# Citizens Coordinating Committee on Friendship Heights

Re: Westbard Self Storage Preliminary Plan No. 12017020280 and Site Plan No. 820170110  
Planning Board Agenda for December 14, 2017 item # 6

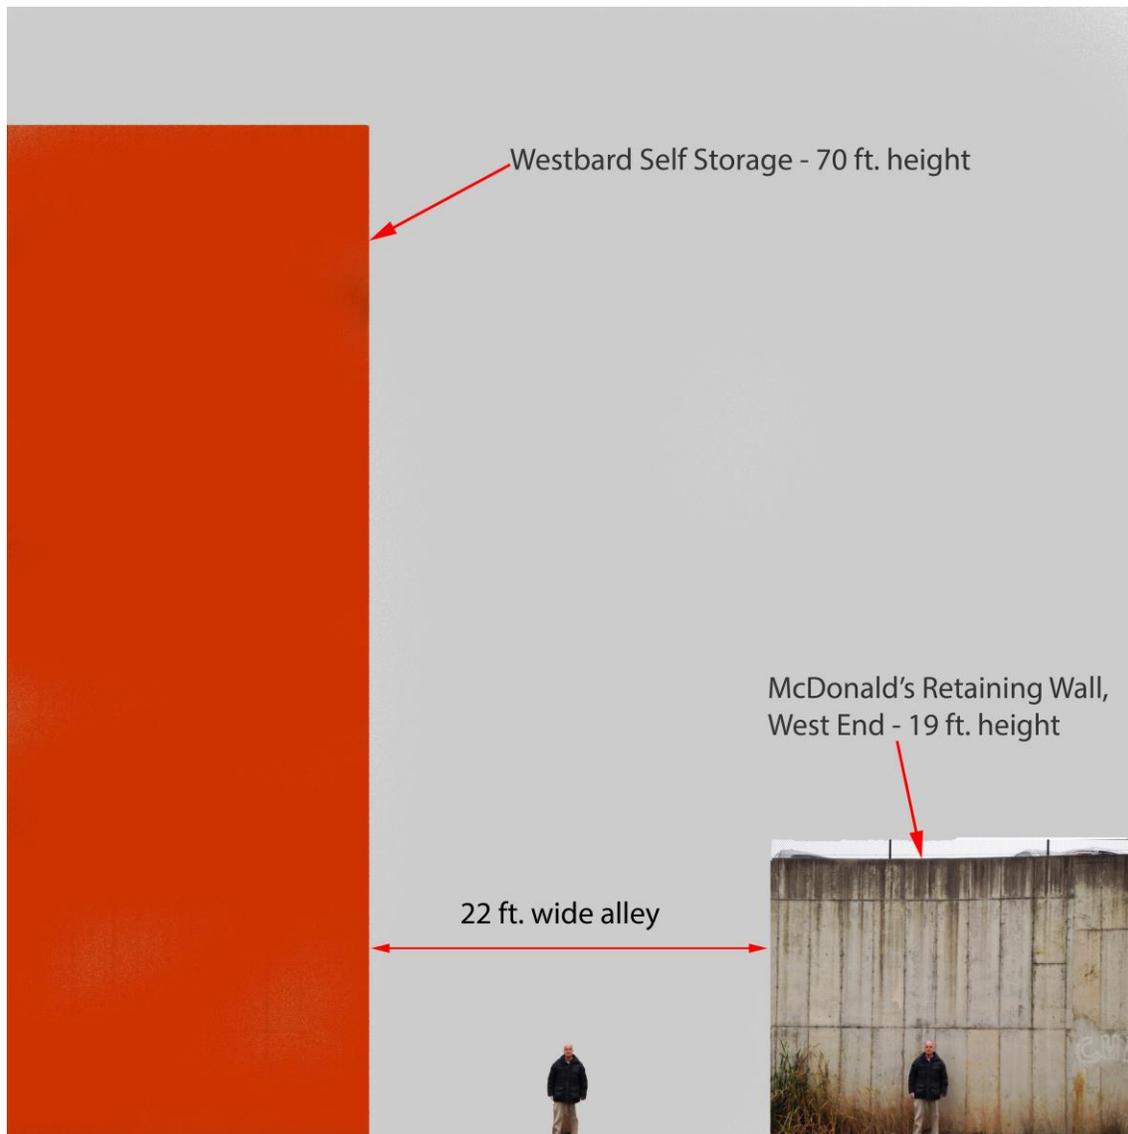
The staff report concludes that the project will provide part of a recommended safe and inviting pedestrian route across Willett Branch for people who want to walk from Westbard Ave. to River Road (p. 38). We strongly disagree. It is anything but inviting and even with lighting will not be viewed as safe. A 195' long alley in an industrial sector with high walls on both sides is a setting that provides a sense of apprehension and entrapment.

Westbard Sector Plan connectivity objective: The Sector Plan contemplated connectivity from the Capital Crescent Trail near River Road, to the Willett Branch, to the major local shopping center on the other side of Westbard Ave (see Sector Plan p. 70 Site 1 & the purple arrow to the east in the Westbard Sector Plan p. 52, reproduced above). In the staff report this very important connectivity path is called Outlet Road or the Outlet Road shared-use path.

This connectivity would be provided in part by an improved and rebuilt path behind commercial properties facing on River Road (see Staff Report pp. 4, 17). There is now a hardscrabble pathway there that is used infrequently by pedestrians and cyclists to travel between River Road and Westbard Ave. (see staff report p. 22). The Outlet Road path is sandwiched between the McDonald's property and proposed storage building.

Proposed Storage Building: To the south of the path, there would be a 58 to 70 feet high building (building of 50' + 8 feet of equipment on the roof (staff report p. 23) + 12 foot of "below ground" level area due to the slope of the property (pp. 3, 16). See generally, staff report page 21 figure 12. To the north of the path there would be the McDonald's wall which reaches 19 feet high not counting

the tall fence on the top of it. To make matters worse, the upper floors of the proposed storage building extend outward of the ground floor (staff report pp. 23, 24). This is the opposite of the design approach in other contexts where above a specified height, buildings are set back at 45 degrees for compatibility and towers are stepped back. The proposal creates a very problematic entrapping/confining perceptual concern.

1. The path should be a minimum of 22'8" wide. That is the width in the sections in the staff report, pp. 23 and 24.
2. The 22'8" should be measured from the building to the further of (1) the property line or (2) the extent of permanent easements for the pathway on the property occupied by McDonald's. In other words, if the Applicant works out easements, its building may be 14'8" feet from the property line. If not, its building is 22'8" from the property line.
3. The upper floors shall not extent over the first above ground floor.
